NAGADI CONSULTANTS PRIVATE LIMITED

Sub : Clarifications for the observations / comments and additional requirements for our report
G(D)4556

Ref: Our report no. G(D)4556, 15th July 2023 for the Proposed Factory of Bellsonica Auto
Component India Pvt Ltd., at Kharkhoda, Haryana

TYPICAL SKETCH OF PILE SECTION AND SOIL LAYERS
(Soil Parameters for Pile Capacity Calculations)

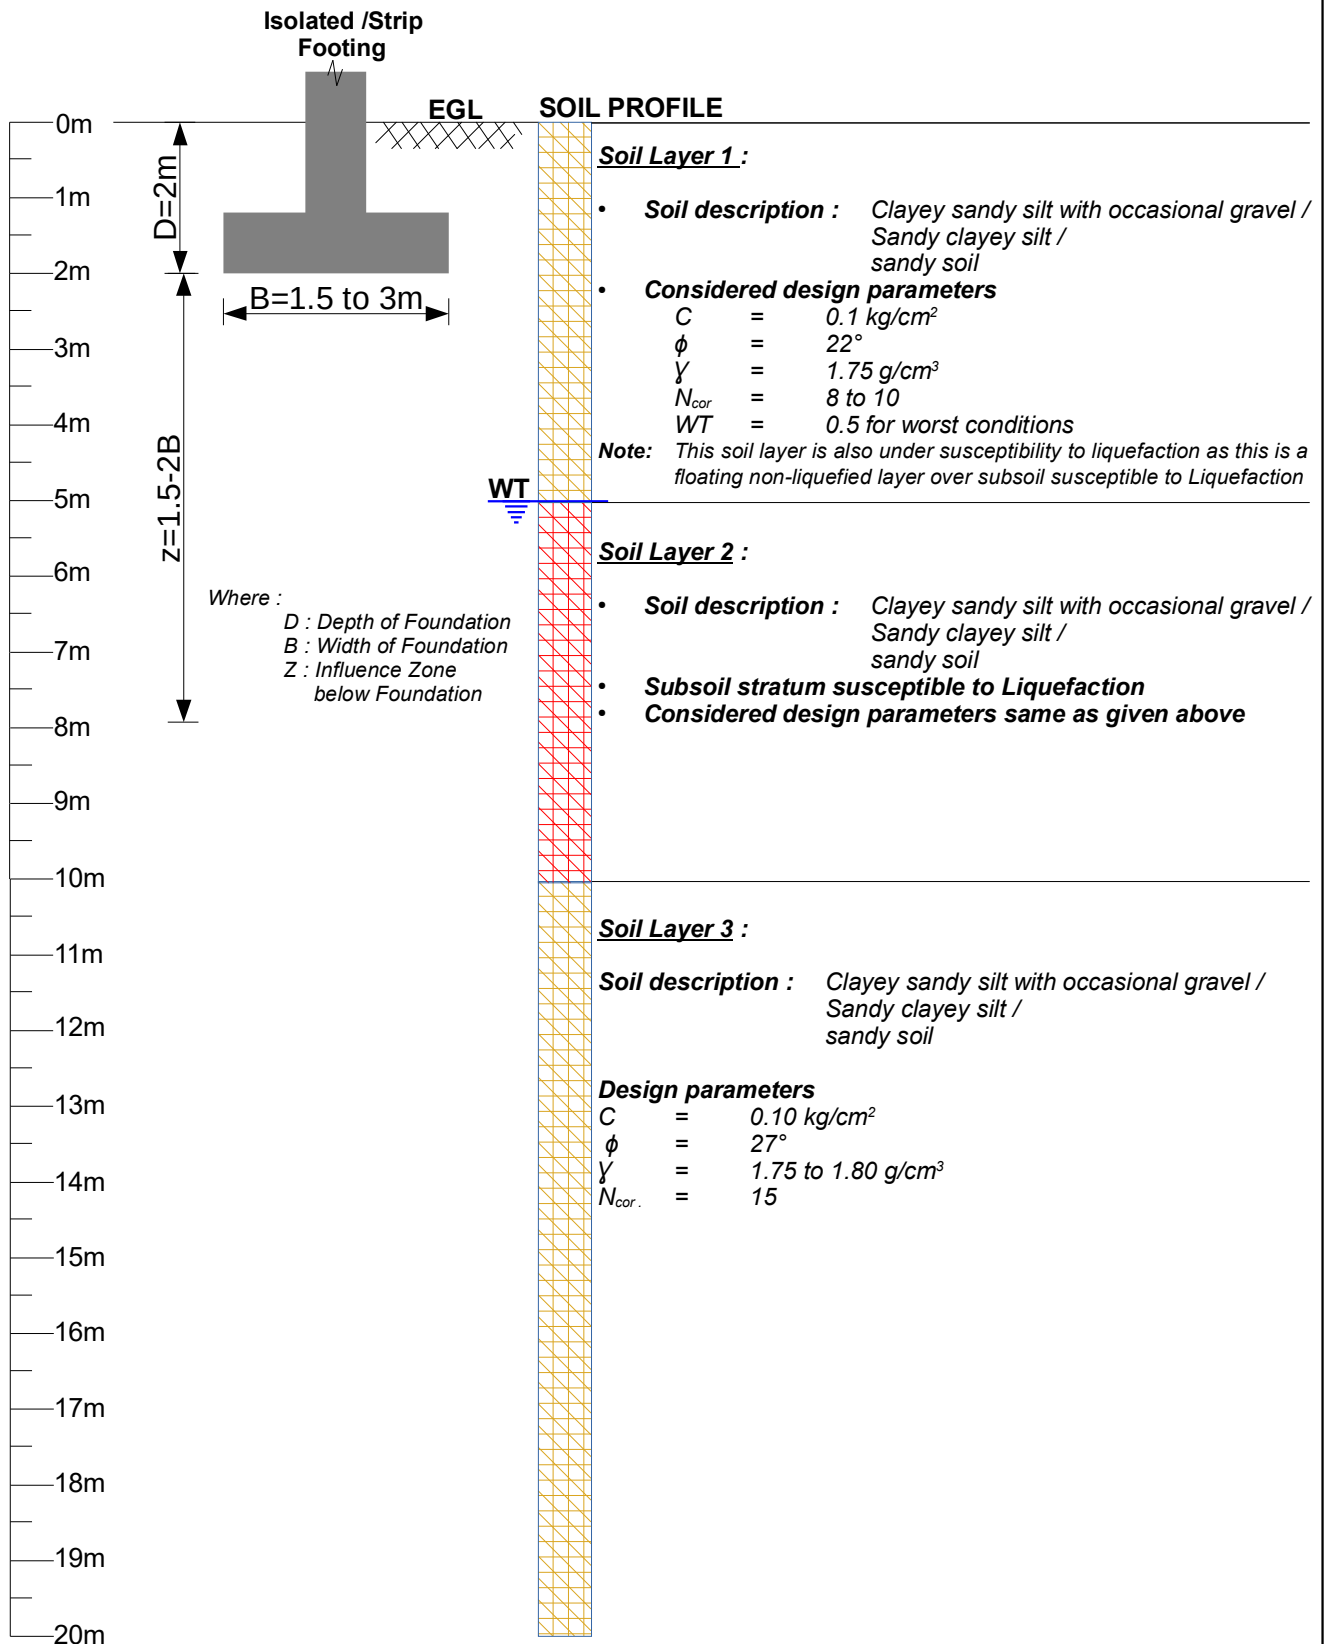
Sr. No.	Client Comment (Takenaka)	Reply (Nagadi)
	Date : 27-07-2023	Date : 31-07-2023
1	Please provide soil parameters summary (layer/strata wise) that need to be used for pile capacity calculation and safe bearing capacity calculation for open foundation based on soil test data's.	Please refer attached soil profile for soil parameters summary for pile capacity calculations and shallow foundations calculations.
2	In your report SBC of soil is mentioned at shallow depth, but we have deep pit, so requested to provide SBC at more deeper level (say 4m,5m,6m,7m & 8m level).	As subsoil strata down to 10m depth has been considered to be susceptible to liquefaction, shallow foundations for any of the major structures are not feasible down to the liquefiable stratum i.e. 10m. However, allowable bearing pressures for Isolated/Strip footings at shallow depths have been provided only for minor structures of less importance at ground level considering that in the event of an earthquake, there is a possibility that the foundations may under go differential settlements which may cause distress to these minor structures and repair/reconstruction of the these structures may be taken up accordingly.
